Contanda Renewable Diesel Bulk Liquid Terminal Development Project Final Environmental Impact Report

Prepared for the Port of Stockton

The comment letter from SAFER CA is provided in the following pages, followed by responses to each comment presented in Table 6.

Figure 2: Air Districts Affected by the Project

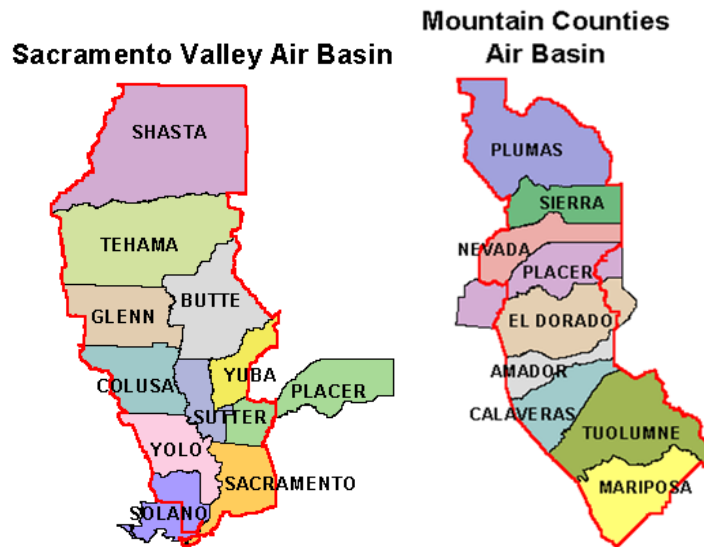
Routes that pass through these other air districts would have much higher emissions than the short segments within the SJVAPCD considered in the Project DEIR. For example, routes that pass over the Sierra Nevada (the Modoc Line route over Donner Pass in eastern Placer County past the City of Truckee to Reno and via the Feather River Corridor via Winnemucca to Reno) are subject to the highest emissions in California due to the locomotives operating at maximum load while navigating the switch-backs up and down the steep slopes of the Sierra Nevada. These emissions could result in significant air quality impacts in these other air districts, as well as significant public health impacts to communities along the rail lines.

The DEIR should be revised to estimate criteria pollutant and DPM emissions in all air districts through which the Project trains travel and compare them to significance thresholds of each affected air district. Further, the DEIR should be revised to include a health risk analysis for communities along any of these potential routes. When preparing such a health risk analysis, care must be taken to use emission factors appropriate to mountainous areas rather than the generic annual average factors used in the DEIR.²¹

Figure 6: Location of Emission Sources

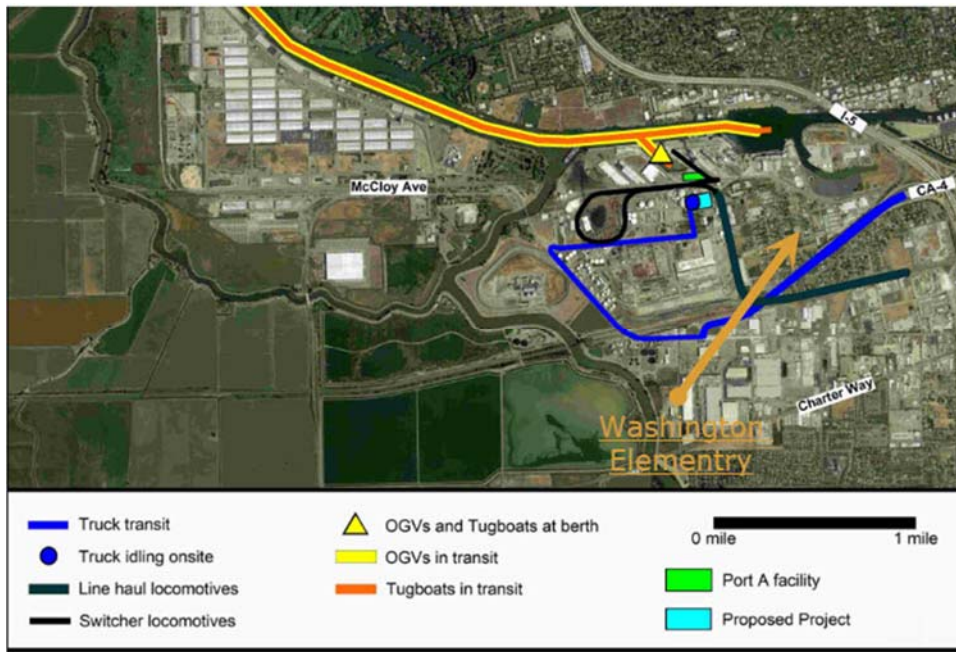
This emission summary indicates that 77% of the DPM emissions come from two sources – the switcher locomotives and OGVs at berth. Figure 6 indicates that these two emission sources are the closest to sensitive receptors (workers, residents, and Washington Elementary School) and thus are the major contributors to health risk. Curiously, the DEIR’s HRA modeled train and truck routes that maximize the distance from these sensitive receptors, rather than the shortest routes that would be used in practice. Thus, it is critically important that these emissions be accurately estimated and modeled. They were not.

Our analyses indicate that the location of the switcher emissions was shifted to the south and west, away from homes. See Figure 6. However, train tracks are very close to homes. See Figure 6. If offsite emissions are closer to sensitive receptors, and Figures ES-1 and 1 in the DEIR⁹⁴ suggest they are, cancer risks at the nearest residential receptor would be much higher than reported in the DEIR and in the corrected analyses we report for Case 2 in Figure 11. Our analysis in Case 2 indicates the cancer risks are highly significant in adjacent residential neighborhoods.

Figure 7: Case 1 – Location of Truck and Rail Routes Modeled in the DEIR's HRA

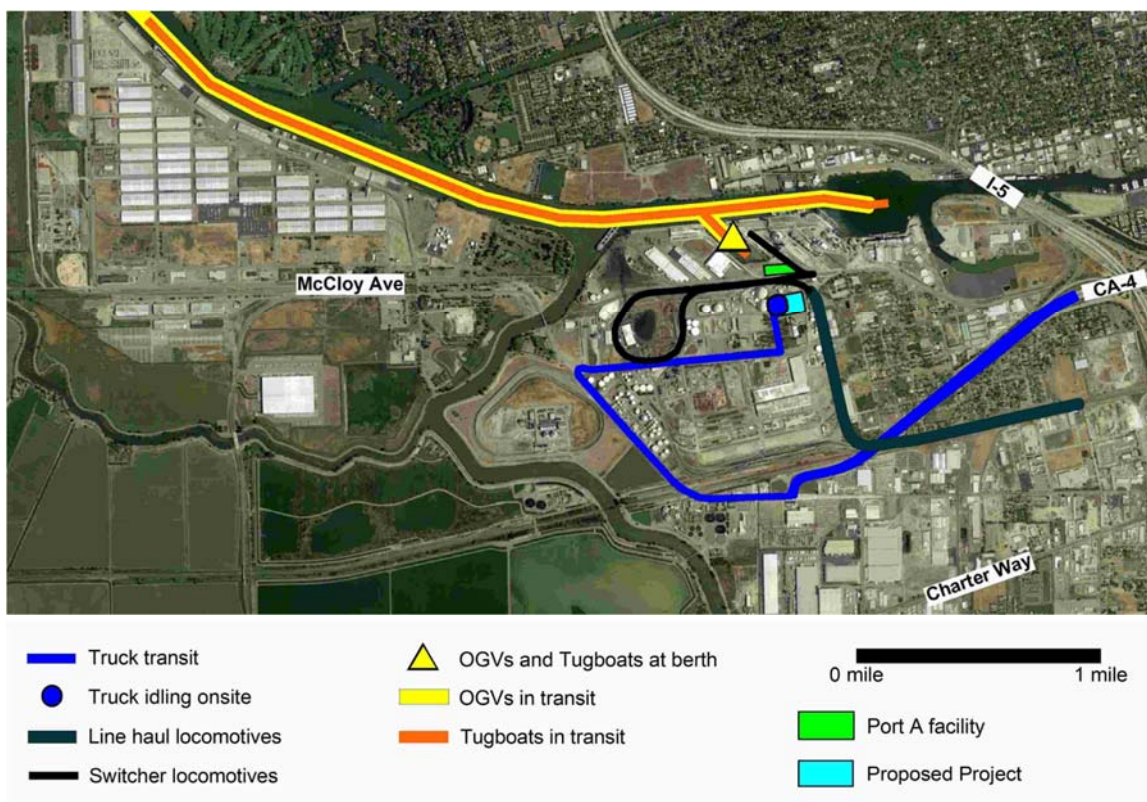
However, our review of Google maps and other information indicates that there are rail lines and truck routes that are shorter and closer to residential areas and would more likely be used in practice. These are shown in Figure 8. Most of the switcher emissions will occur closer to the Project site than shown in Figure 6 because that is where switching operations will take place. Comment 5.6.2.1. Further, trucks are most likely to take the shortest route from I-5 to CA-4, as shown in Figure 8, not the longer route shown in Figure 7. Our review of the HRA modeling files also indicates that the hours of operation of switching and berthing were

Figure 10: Case 1 – Cancer Risk Isopleth Map

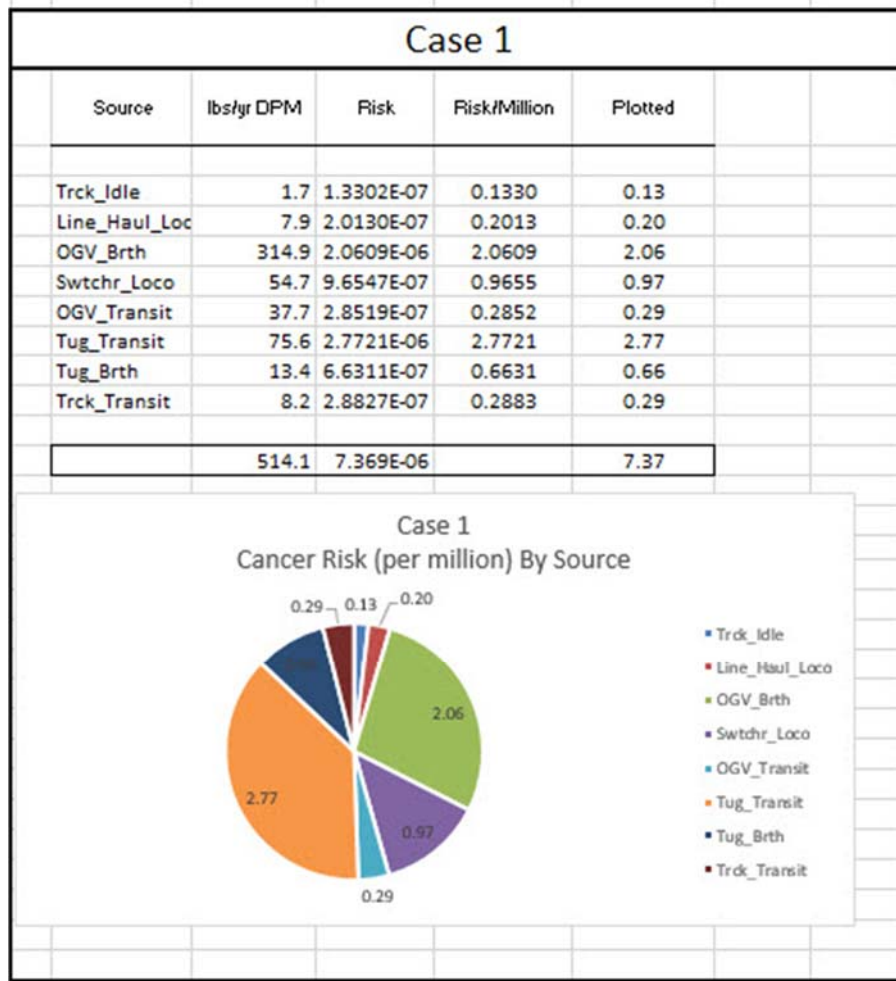
We attempted to reproduce the DEIR’s HRA results by trial and error location of line sources, yielding an MEI cancer risk of 7.4 in one million (Figure 9), compared to the value reported in the HRA of 7.0 in one million.⁸⁸ Our results, called Case 1, are presented in Figures 9 and 10. These figures represent our best estimate of future residential risks, given the scope of the Project.

Figure 11: Case 2 – Revised Health Risk Assessment

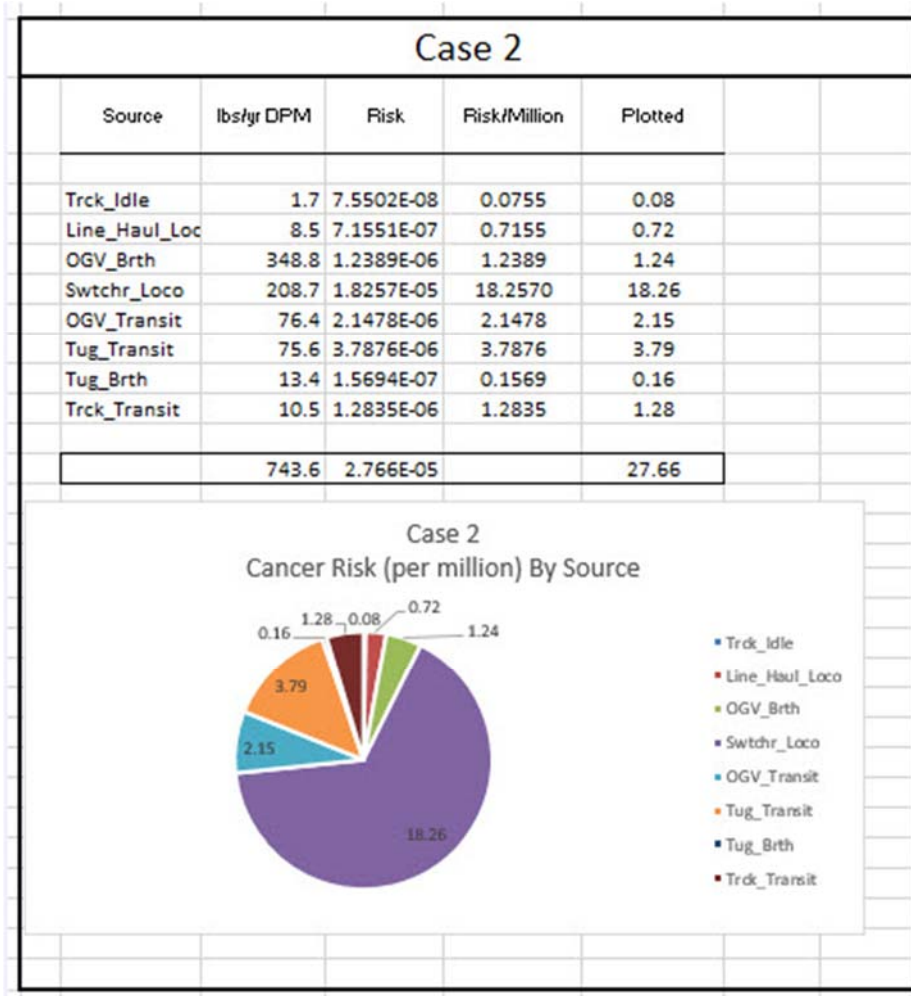
retaining the DEIR’s assumptions. The results of our analysis, Case 2, are shown in Figures 11 and 12.

Figure 12: Case 2 – Isoleth Map

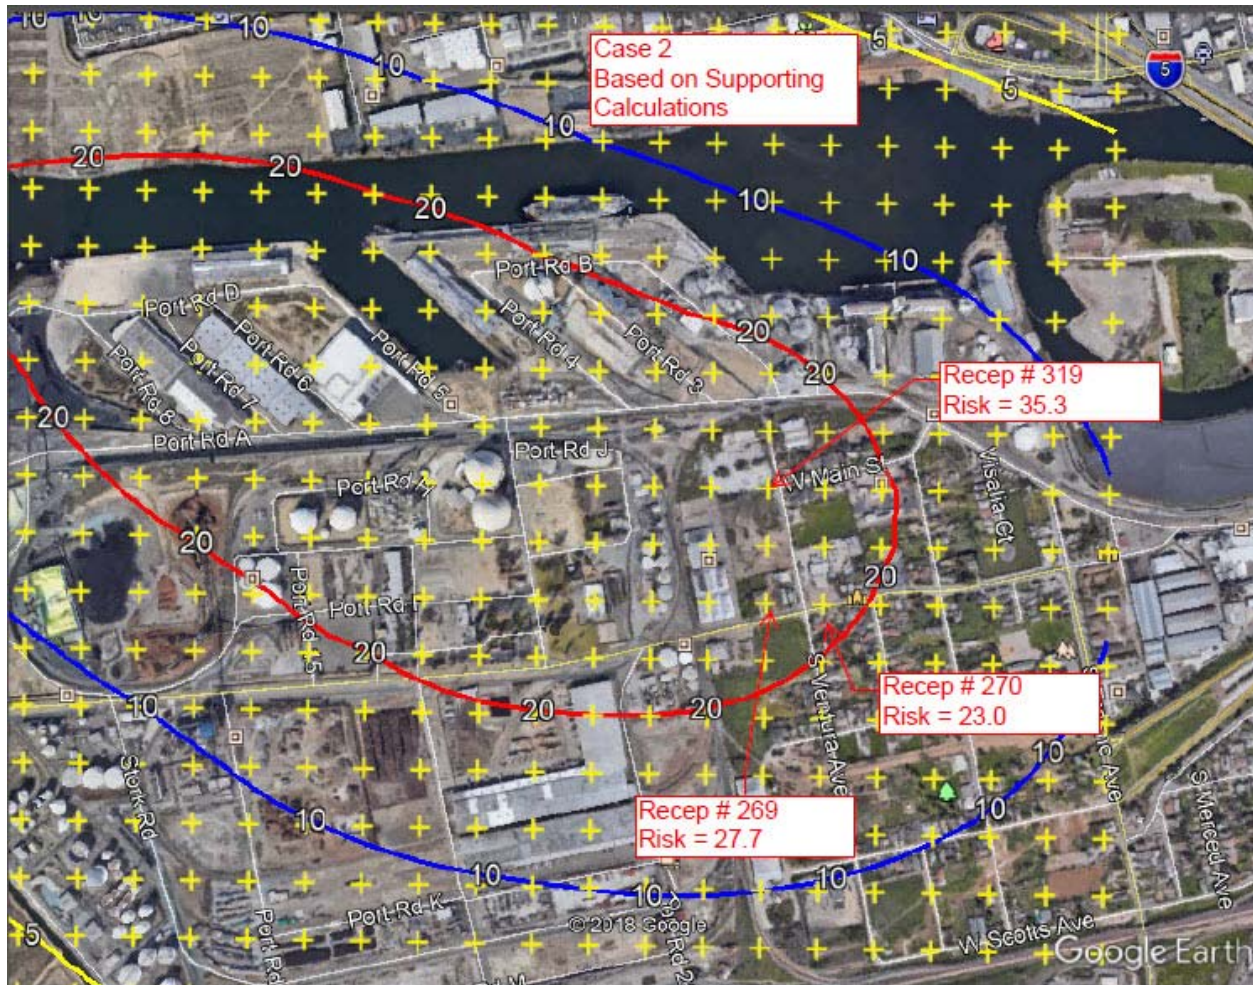
Figure 12 shows that the 30-year cancer risk at the nearest home (receptor #269) is 27.7 per million, compared to the DEIR’s cancer significance threshold of 20 per million. Thus, residential cancer risks are significant. Figure 12 also shows that other residences in the general area of the MEI will also exceed the cancer significance threshold. Thus, without enforceable conditions requiring the assumptions modeled in the DEIR’s HRA, the DEIR must conclude that residential cancer risks are significant and propose enforceable mitigation.

Further, Figure 12 indicates that there are other locations that have higher risks than at the MEI. However, the information available to us suggests those locations currently do not have residences. Based on our review of Google maps, locations with these higher risks (greater than 27.7 cancers per million) likely have outdoor workers. The DEIR’s worker HRA includes all of the errors and omissions discussed above for residential exposures. We did not have time to redo the operational worker HRA. A revised DEIR should be prepared that includes an updated worker HRA.
